# CITY OF ALBUQUERQUE

**RE: MDS - Montage Subdivision Unit 7 on Bobby Foster  
Grading and Drainage Submittal for Preliminary Plat and Grading Permit  
Grading Plan Engineer's Stamp Date: 7/13/22  
Drainage Report Engineer's Stamp Date: missing  
Hydrology File: R16D100A**

**MONTAGE 7 SUBDIVISION AT MESA DEL SOL  
DRAINAGE STUDY**

## Street Capacity Calculations

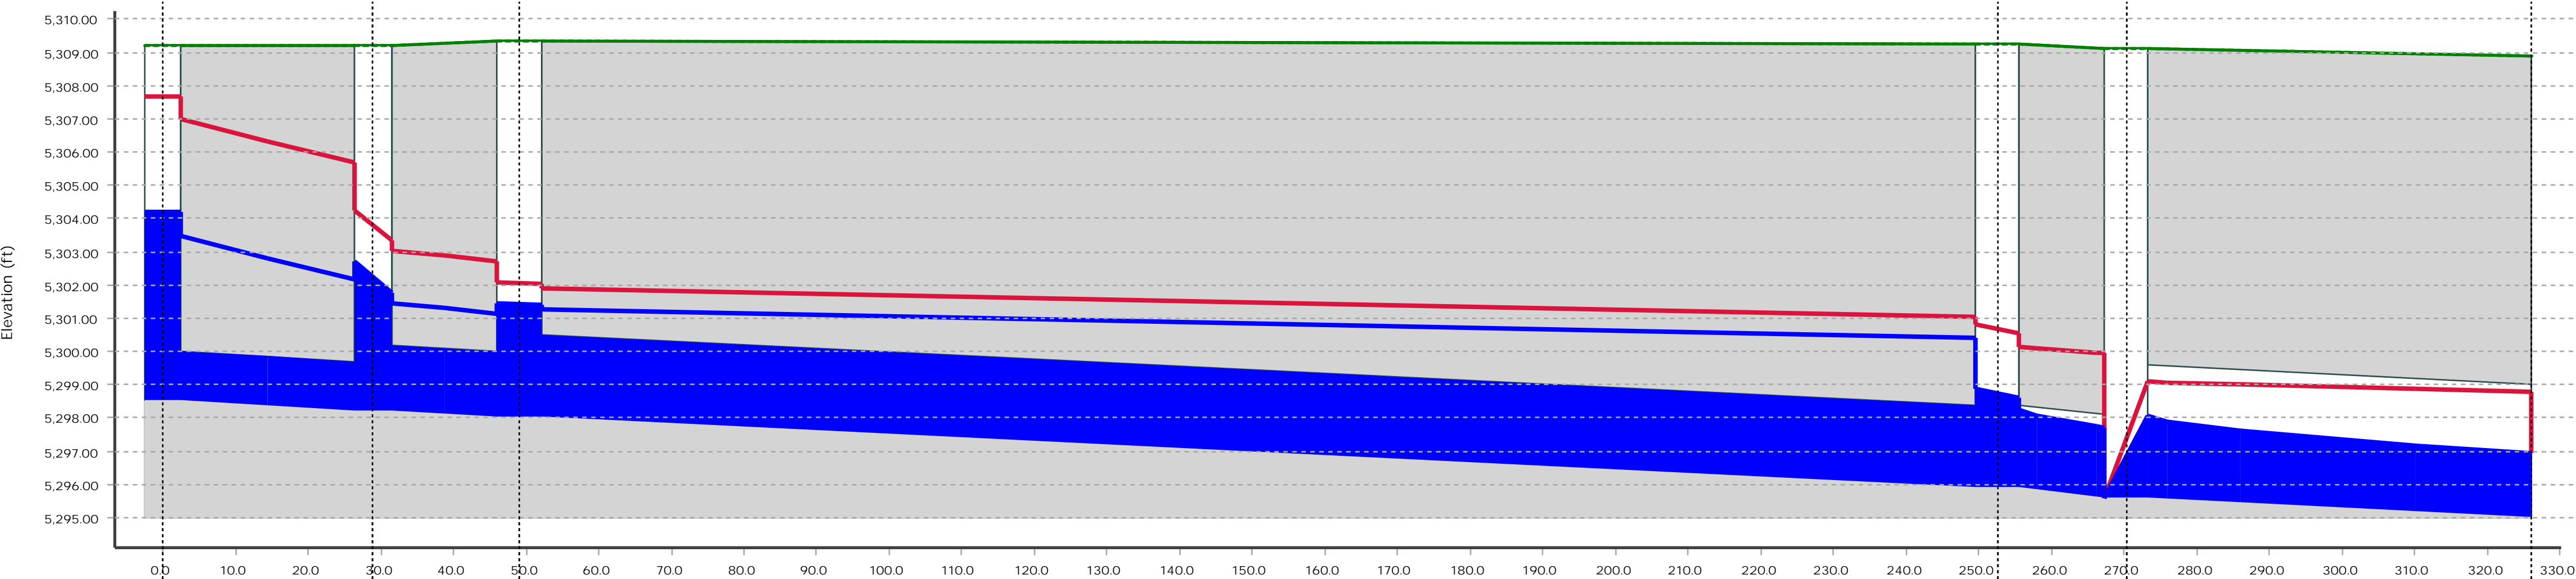
3. Table 3 on page 3 of this Montage Unit 7 report overestimated the capacity of the Alleys and of Newhall Dr.

- a. The city doesn't allow 100 year flow depth over the top of the curb, so the alley capacity of 14.7 cfs is overestimated since the flow depth 4.7" in the calculations exceeds the 4" curb height.
- b. Similarly the Newhall Dr. Street capacity of 48.75 cfs is overestimated since the flow depth 8" in the calculations exceeds the 6" curb height.

The Newhall Dr. surface capacity is about 25 cfs for 6" deep flow at 0.5% slope, and the alley capacity at 4" deep flow in a (normal crown 24' FF) at 0.5% longitudinal slope is about 8 cfs.

Provide surface drainage analysis demonstrating that the 100-year HGL remains at/below top of curb, and the 100-year EGL remains within the ROW for the onsite streets and alleys and the adjacent streets that receive drainage from this site per DPM 6-9(A).

## GRADING COMPOSITE

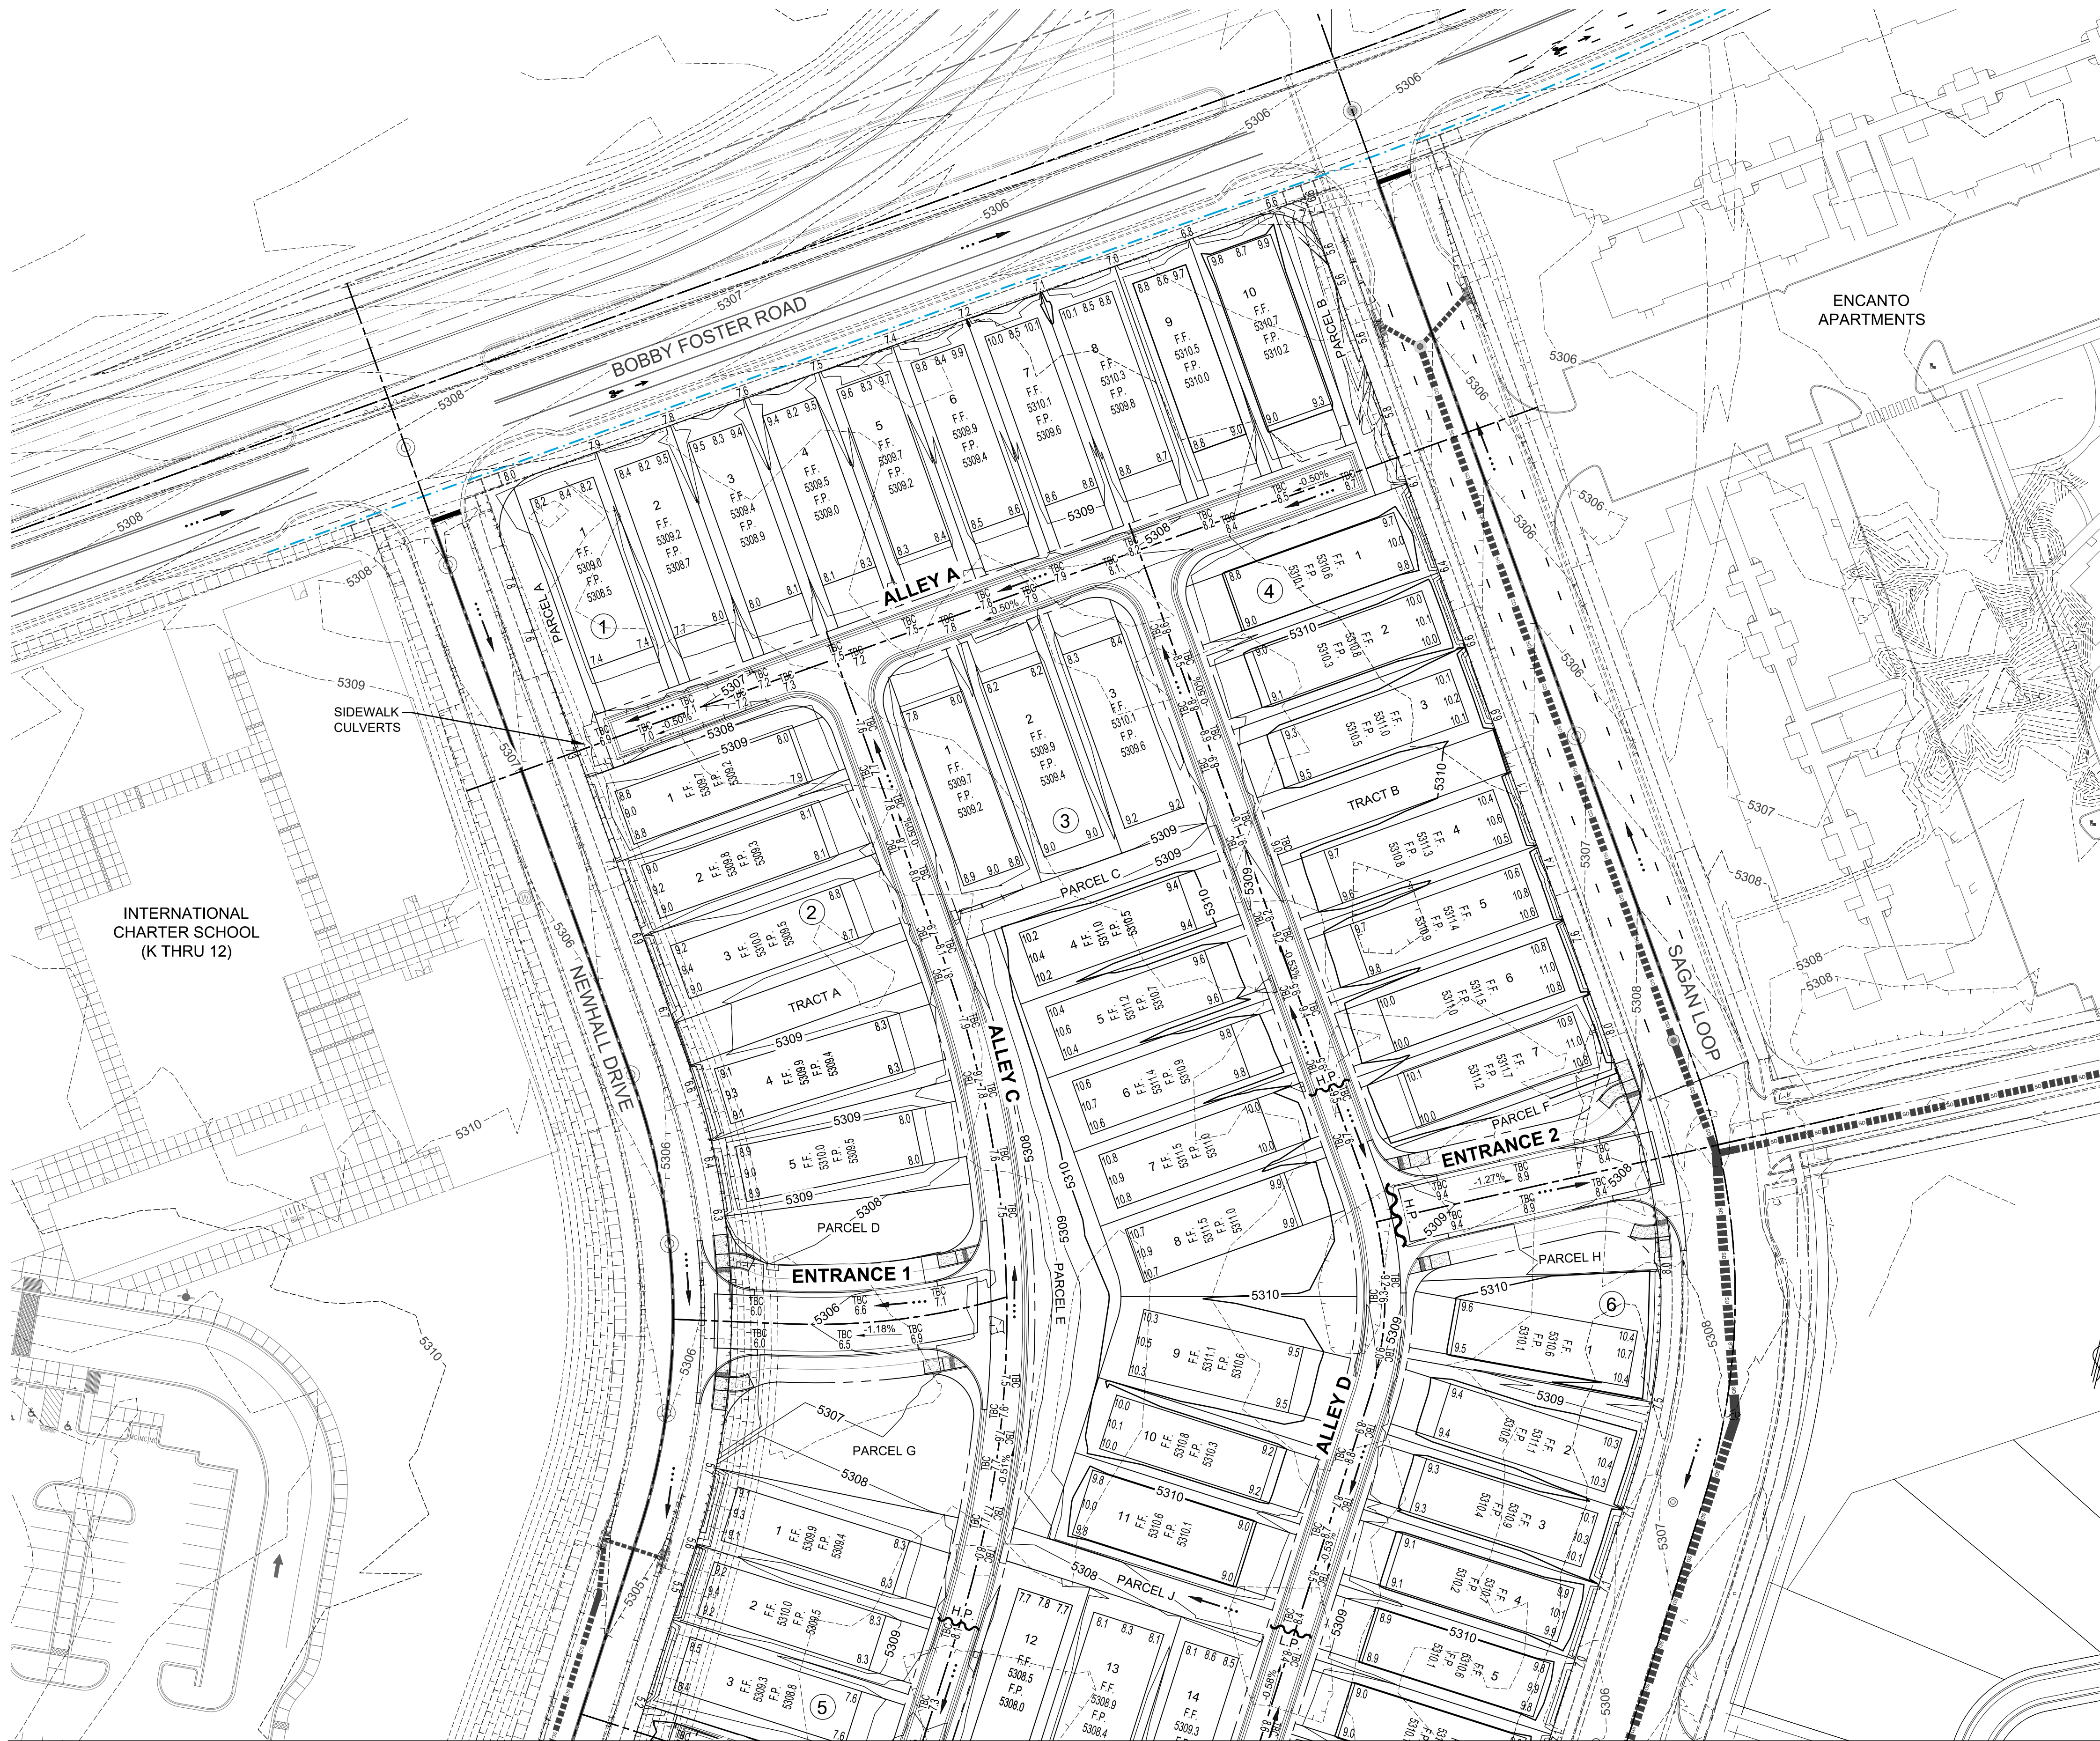
1. The Grading Plan that was missing from the first submittal was provided with this second submittal, but it is still missing typical sections of streets, alleys, retaining walls, and other details on the Grading Plan Checklist, DPM 6-14(C). The new plan raises these additional concerns.

- a. Please provide the Benchmark information (location, description and elevation) for the survey contour information provided.
  - b. Please provide the FIRM Map number in a flood plain note with effective date.

- c. Please provide a legal Description of the property.
  - d. Show both existing and proposed storm pipes and inlets with sizes.
  - e. Show sidewalk culverts in Parcels A & K, box culvert in Parcel G, and drainage channel in Parcel J labeling the number, size, and type of each. Add details of connection to streets at both ends of each.

- f. Provide typical sections of drainage structures thru Parcels A, G, J, and K with material specifications, lot lines, and dimensions.
  - g. Add valley gutters through the alley intersections. Provide valley gutters at each of the four alley intersections in accordance with the Intersection standard DWG 2401 and Concrete Valley Gutter standard DWG 2420.

- h. The highest point at entrance 2 is at the valley gutter for Alley D; so, Alley D will drain out the entrance to Sagan Loop contrary to the drainage Basin Map. Instead provide a water block farther to the east in entrance 2 to and adjust the Basin Map accordingly.

- i. Add a typical lot grading detail with typical section through the side yards at the front corner of the houses. The plan should clearly indicate which portions of each lot drains to the alley and to the street.

- j. Add typical sections from the house pads to the existing adjacent street showing the maximum grade change between pad and street. Show how that grade change is to be accomplished on the private property, while maintaining the required typical sections within the public right of way per COA DWG 2414. Correct the grades shown on the sidewalk around the perimeter to agree with the projected 2% grade shown on the detail.

- k. Identify Landscape Buffer Swales per COA DWG 2414 along all of the adjacent public streets with a hatch pattern in the legend and in the plan view.

- l. Identify all right-of-ways and drainage easements.
  - m. The layout and sections of the streets, alleys, and sidewalks as shown on the Grading Plan must match the Traffic Circulation Layout, but a traffic plan hasn't been submitted yet. So, a condition of approval will be that the sections match and the G&D Plan will have to be revised if they don't.
